TO: Mercedes-Benz Dealer Principals, General Managers, Sales Managers, Service Managers, Parts Managers	FROM: Heike Scheuble, General Manager, Aftersales
RE: Recall Campaign Notification MY19 907 (Sprinter) Bolt Connection between Steering Shaft and Steering Gear	DATE: January 28, 2019

Campaign No. 2019010006, January 2019

SUBJECT: **Model 907 (Sprinter), Model Years 2019**
Bolt connection between steering shaft and steering gear

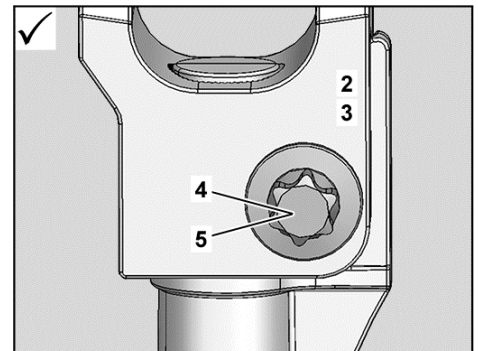
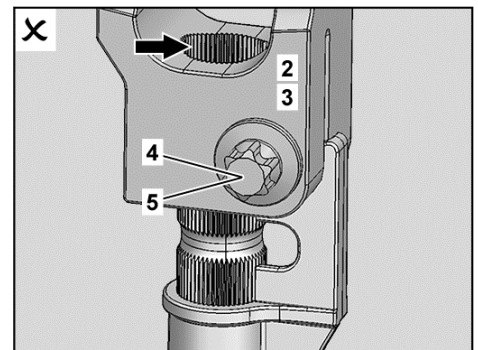
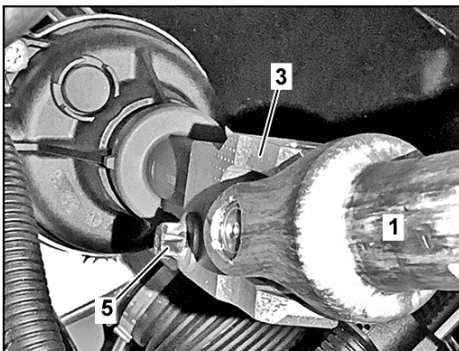
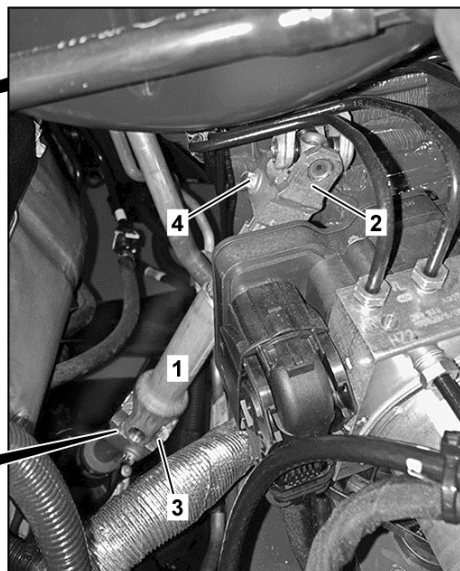
- 1 Steering shaft
- 2 Universal joint
- 3 Universal joint

- 4 Screw
- 5 Screw

2	Check threaded connection at universal joints (2, 3)	<p>Check, whether screws (4, 5) installed. To do this, turn in the steering until the respective screw (4, 5) is visible and accessible. Then check both universal joints (2, 3) for correct seating (see picture). The gearing (arrow) must not be visible.</p> <p>Screw steering shaft at bottom of steering gear</p> <p>Screw steering shaft to steering shaft bearings</p> <p>If one or both screws (4, 5) are installed and the respective universal joint (2, 3) is correctly aligned,</p> <p style="text-align: center;">↓</p> <p>tighten the respective screw (4, 5). If the universal joint (2) or universal joint (3) is not aligned correctly,</p> <p style="text-align: center;">↓</p> <p>align affected universal joint (2, 3) correctly, fasten and replace corresponding screw (4, 5). Remove and install lower steering shaft</p> <p>If one or both screws (4, 5) are not installed,</p> <p style="text-align: center;">↓</p> <p>correctly align respective universal joint (2, 3), fasten and subsequently screw in missing screw (4, 5) and tighten. Remove and install lower steering shaft</p>

3	Mark renewed or retightened screws on the screw head with green colour.

Number	Designation	Model 907, 910
BA46.10-N-1001-05TS	Screw steering shaft at bottom of steering gear Nm	28

Number	Designation	Model 907, 910
BA46.10-N-1004-05TS	Screw steering shaft to steering shaft bearings Nm	28
